ADDENDUM

ADDENDUM #: 03
DATE: February 23, 2026
BID DATE: February 27, 2026, 2:00 PM
SUBMITTED BY: Verde Design Inc.
PROJECT: Lodi High School Athletic Field Improvements
VERDE'S PROJECT NO.: 2502700
FILE NAME AND PATH: Y:\Projects-FO\2025\2502700 - Lodi HS Baseball and Softball Field\Construction Services\Bid Items\20260223_Bid Addendum 03

The changes, clarifications, or modifications to the Lodi High School Athletic Field Improvements Construction Drawings are as follows:

L0.1

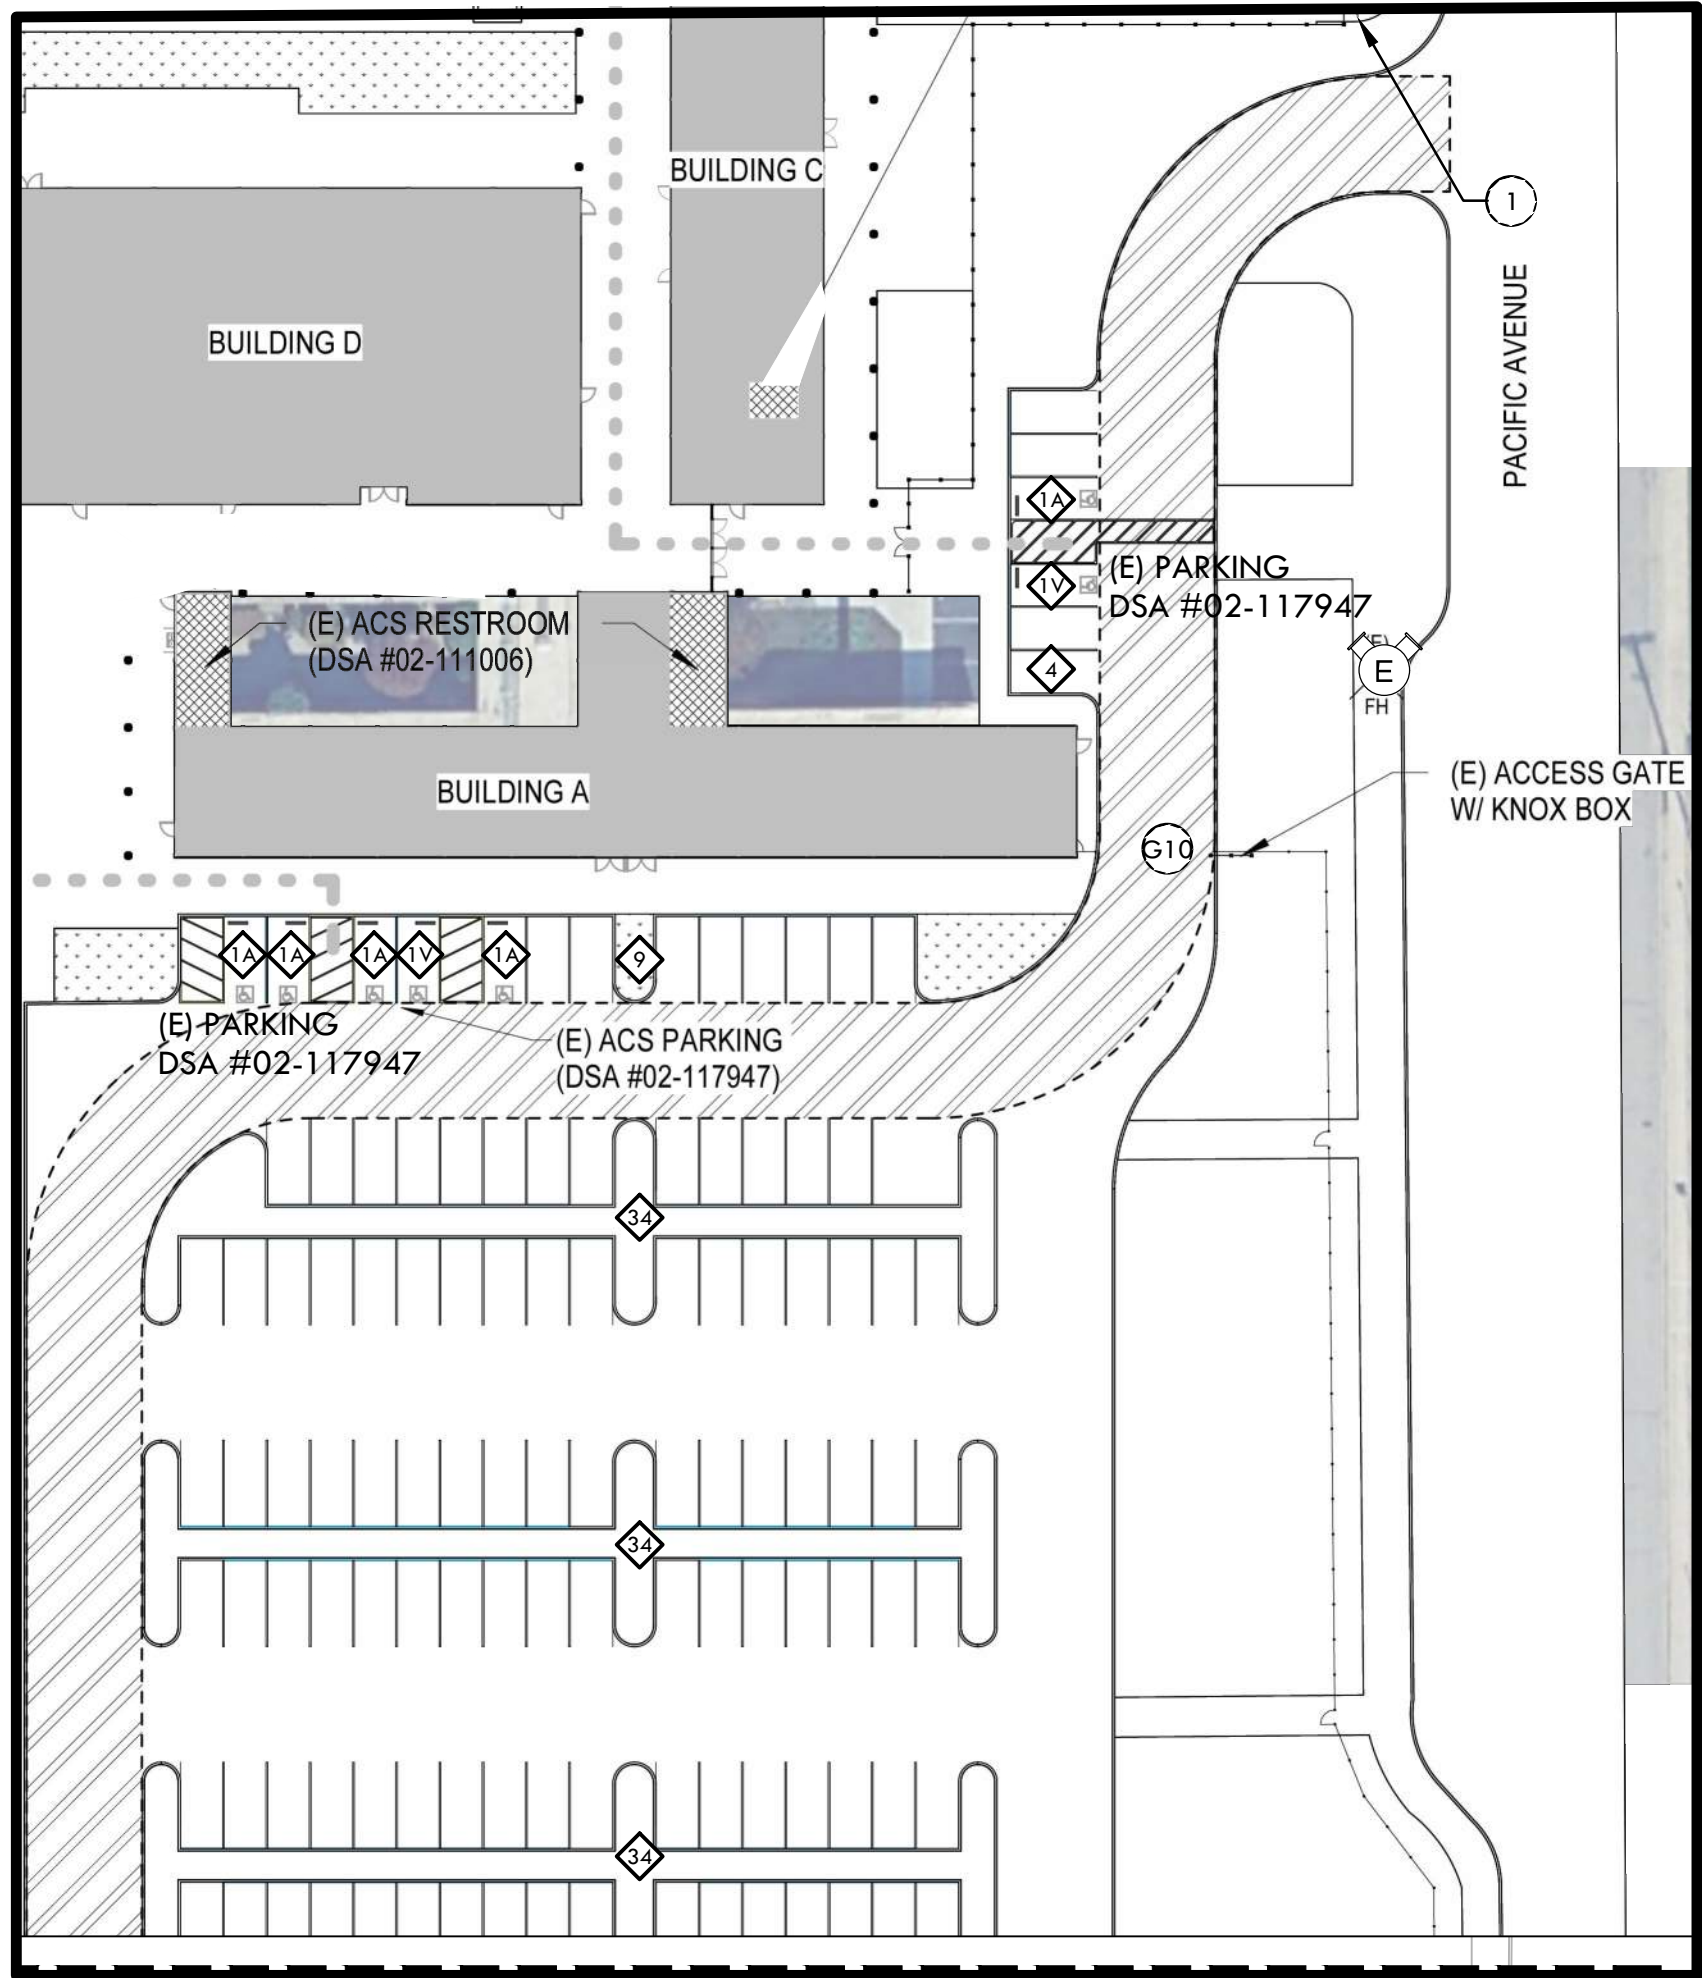
L0.1 – Accessibility Plan

1. Accessibility Legend has been revised to include an additional gate callout – 7' Tall x 24' Wide Double Swing Gate
2. 7' Tall x 24' wide double swing gate has been identified on the plan set.

SHEET NO.
L0.2

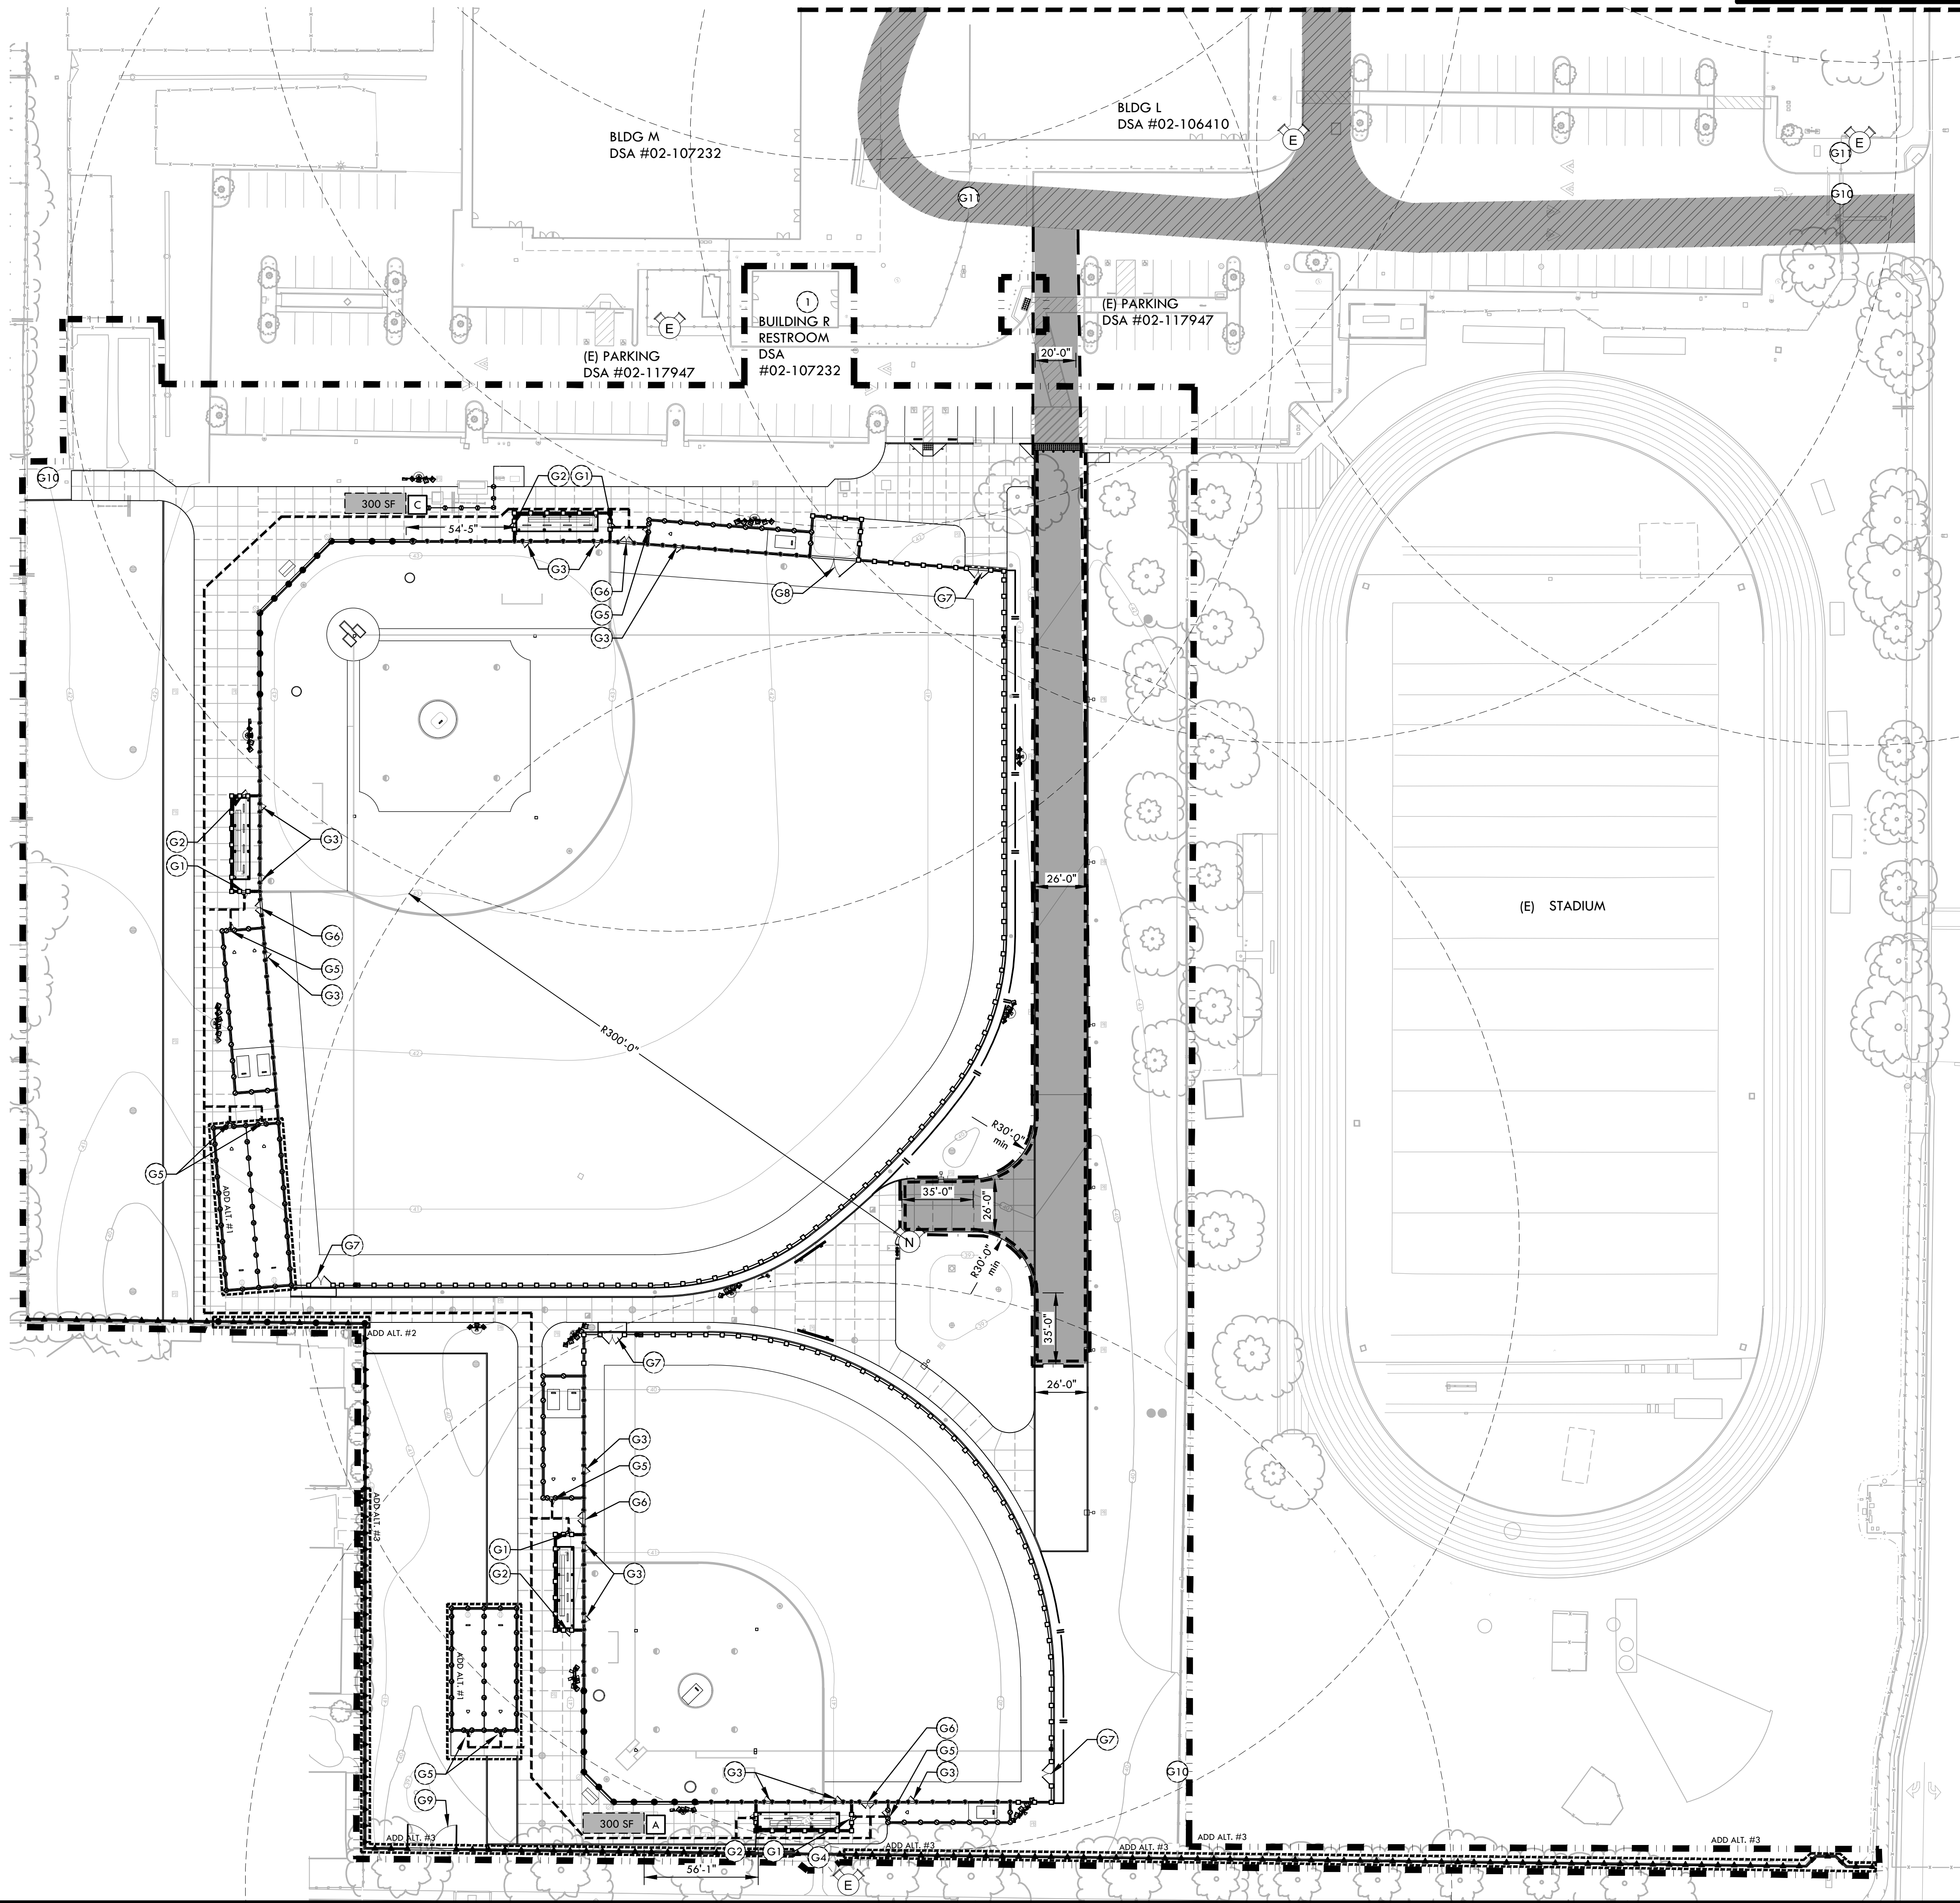
L0.2 – Fire Life Safety Plan

1. Fire, Life & Safety Legend has been revised to include an additional gate callout – 7' tall x 24' wide double swing gate
2. 7' tall x 24' wide double swing gate has been identified on the plan set.

DRAWN BY	CHECKED BY
HM	CS/MB
DATE ISSUED	SCALE
02/23/2026	1" = 20'-0"
PROJ. NO.	
2502700	
SHEET NO.	
L2.2

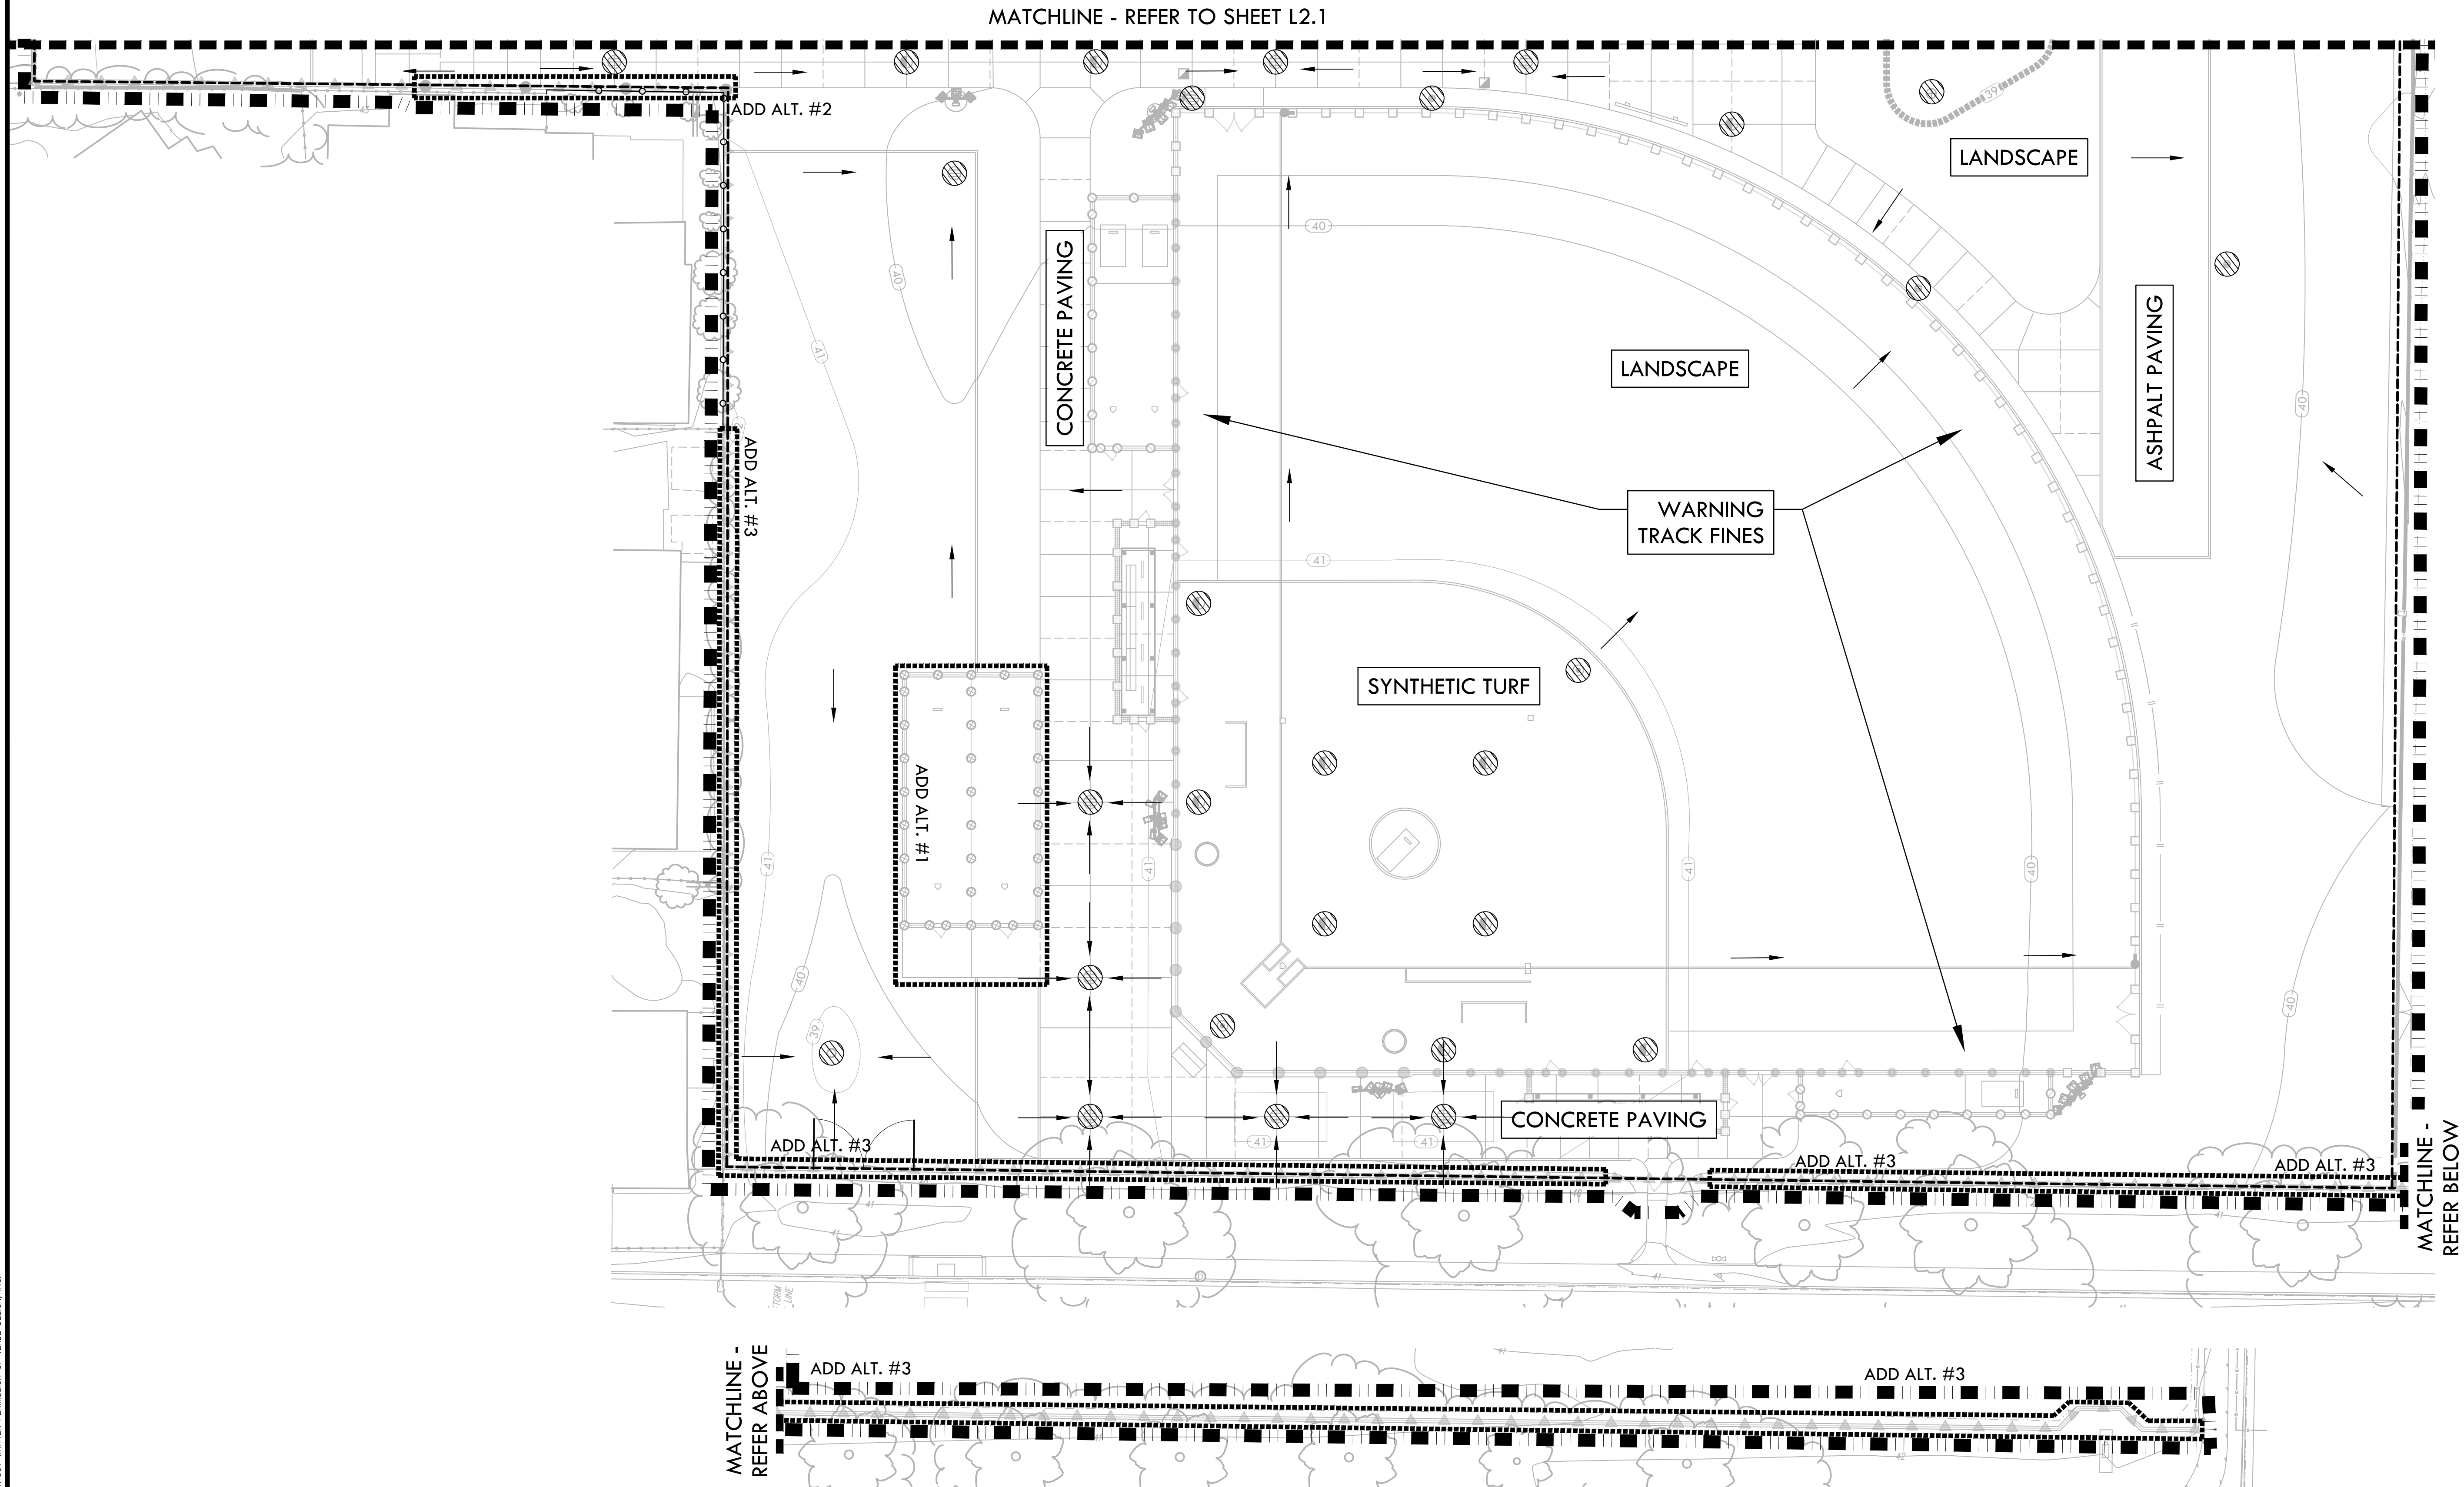
L2.2 – Erosion Control Plan

1. 7' tall x 24' wide double swing gate has been added to the plan set.
